MEMORANDUM

Subject: Proposed Bay of Islands Marina Precinct and Mixed-Use Zoning and Mixed Use Zoning.

Ref #: 25061_01

Plate 1. Opuia Settlement Extents (reproduced from Urban Design Evidence).

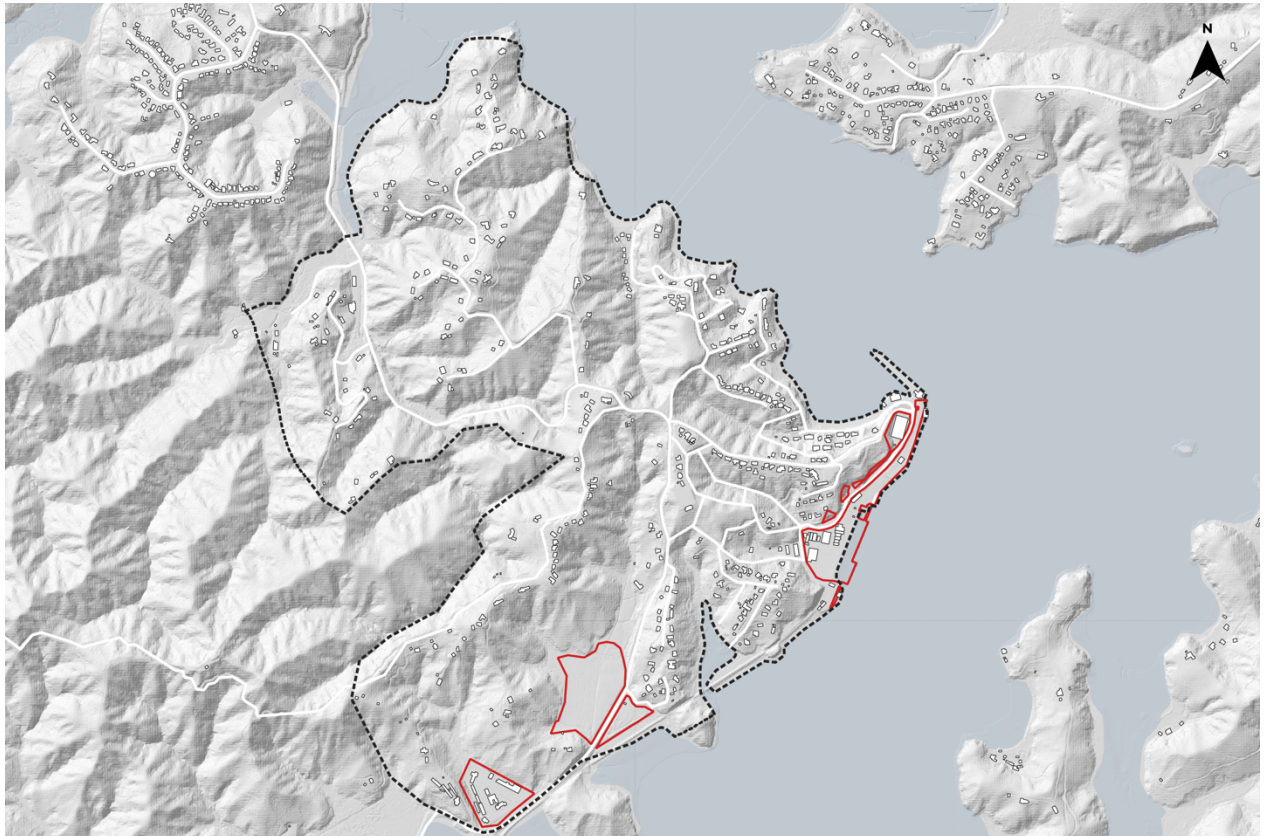
“When looking at the figure 5 of Appendix 1 attached to my evidence the extent of Opuia settlement in my view goes beyond the zones currently highlighted as Urban. First of all the Opuia Commercial Estate is located at the fringe of the township. It bookends the extent of the Opuia settlement area to the south. When looking north, a small mixed-use area along SH11 bookends the northern extent of the Opuia settlement area”²

Mr Lonink argues that his analysis shows that the urban extent of the Opuia Settlement does not fully align with the proposed zoning.

The approach to assessing the urban extent of the Opuia settlement adopted by John Lonink has been to evaluate lot size and built density. In my view this is a little misleading. My perception of the character of the Opuia settlement is based on observation of landscape character and is principally informed by the relationship of built form to the topography and vegetation patterns.

Figure 1 in my attachments is a modified version of Figure 5 of Appendix 1(attached to the evidence of John Lonink). This figure illustrates how the settlement pattern of Opuia are strongly influenced by the terrain, with dwellings constructed along, or close to the ridge crests, whilst the intervening gulleys are retained in native vegetation. Generally, dwellings have located to benefit from views to the Bay, Veronicas Channel or Waikare Inlet and this is reflected in the large proportion of dwellings being located on ridges and spurs to the east of the main north – south aligned catchment boundary ridge. Where dwellings are located to the west of this ridge, these often ‘sneak’ views to the water, or are elevated sufficiently to gain distant views (such as properties along Oromahoe Road).

FAR NORTH HOLDINGS LIMITED
Proposed Bay of Islands Marina Precinct and Mixed-Use Zoning
 FIGURE 2b: Proposed Marine Park mitigation concept

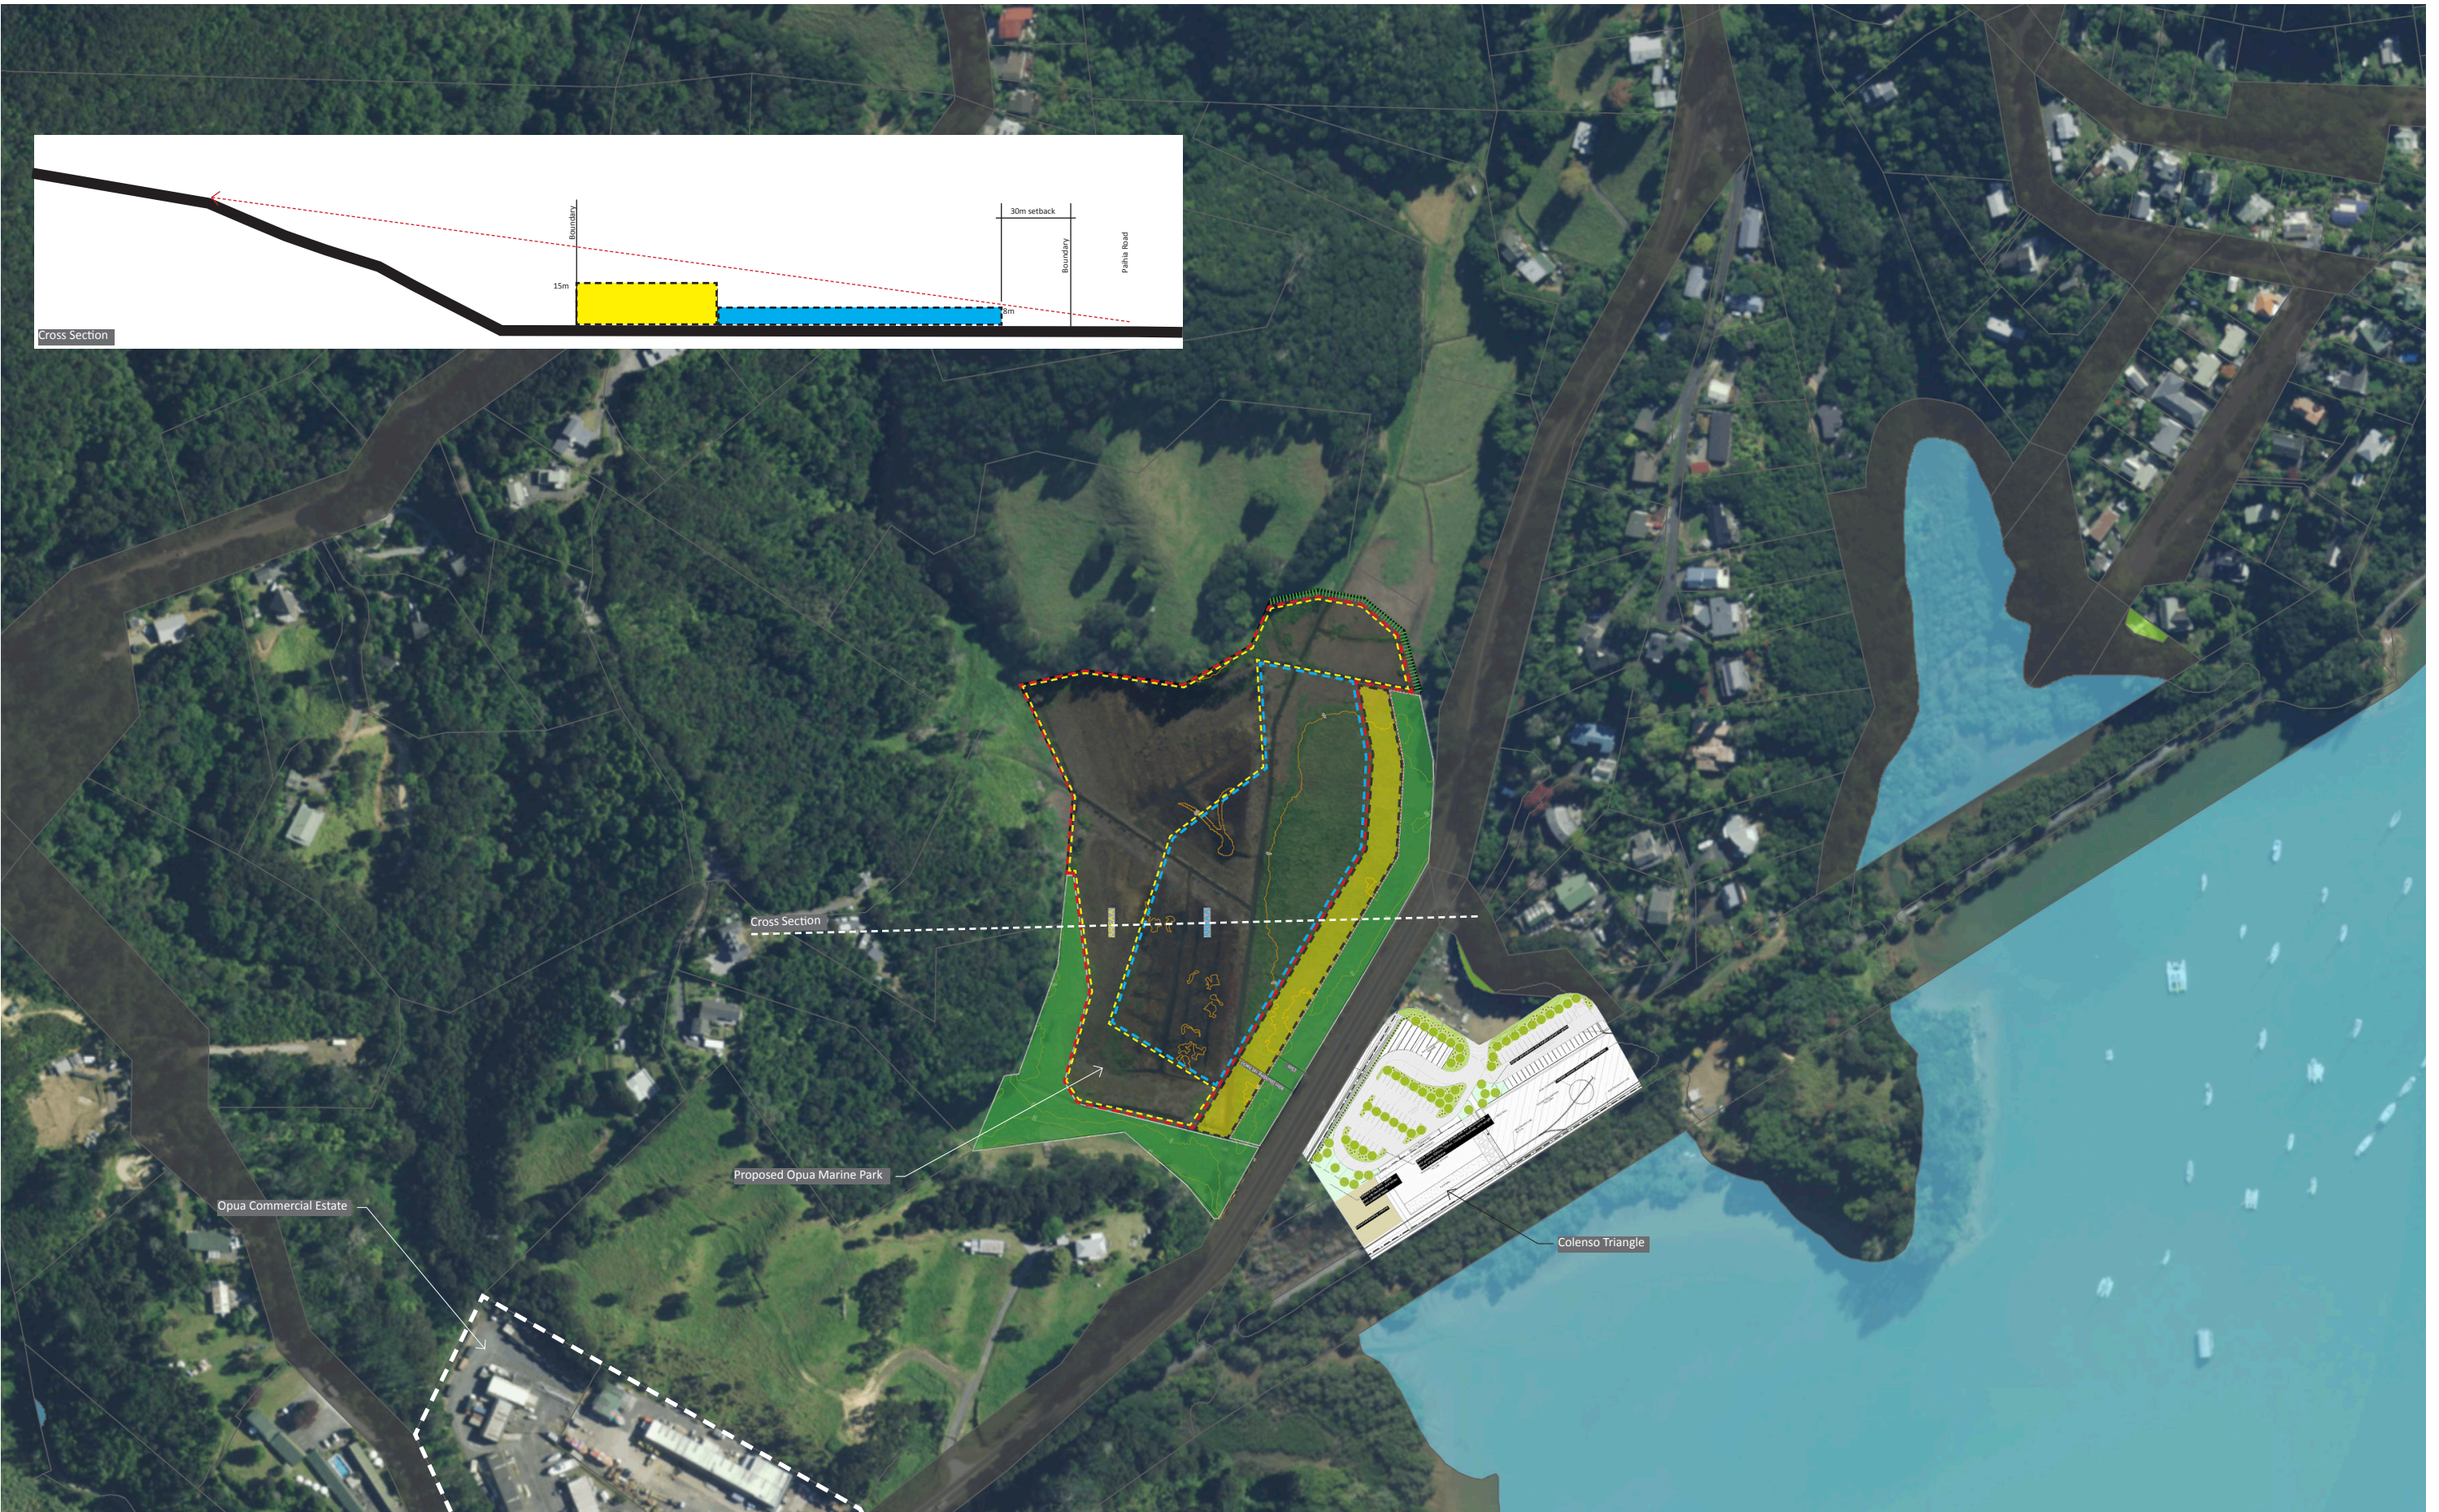
While this site is not in its natural state, I think it retains a degree of rural character. It also sits in front of attractive pasture and bush clad hills, when viewed from SH11. Development along the lines sought by FNHL would need very careful management to ensure appropriate mitigation that successfully integrates any development into this more rural setting.

The preliminary proposal is that a suite of mitigation measures, partially facilitated via a conceptual development plan and development guidelines (refer to Figures 2b and 2c and Table 1 below), and also via modified standards for the MUZ (to be developed) be employed.

Mitigation Measure	Purpose
30m building set back from road boundary.	<p>It is envisaged that the roadside 15m width of this strip will be occupied by stormwater detention / wetland and riparian planting and it is anticipated that the proposed development area will be buffered from view by this landscape buffer strip.</p> <p>It is recommended that the species mix reference the coastal / estuarine location, and that a dominance of species such as harakeke and tī kōuka be included, with occasional groups of taller tree species such as kahikatea. It is intended that the planting design ensure that views of the setback area, and much of the built form beyond are buffered, but glimpse views to the backdrop vegetated ridge flank will be allowed. [Overrides MUZ-S8]</p> <p>The distance of the proposed setback reflects the set back of built form within the consented Colenso development (an area occupied by car parking), and will mitigate the potential for dominant built form along the road corridor, and will ensure that views to the backdrop vegetated ridge flank will be retained. [Overrides MUZ-S3]</p>

Native revegetation planting	<p>Wrapping around the western, south western and southern edges of the development area, this area of revegetation planting will comprise locally appropriate species, and will 'extend' the existing native forest up to the boundary of the development area. This will assist with the integration of the development with its vegetated setting.</p>
Maximum building height 'plane'	<p>The portion of the development site that will be subject to built form will be subject to height restrictions that ensure that views from the road to the backdrop vegetated ridge will be maintained. (OMB) Area B-8 will be closest to the road and within this area building</p>
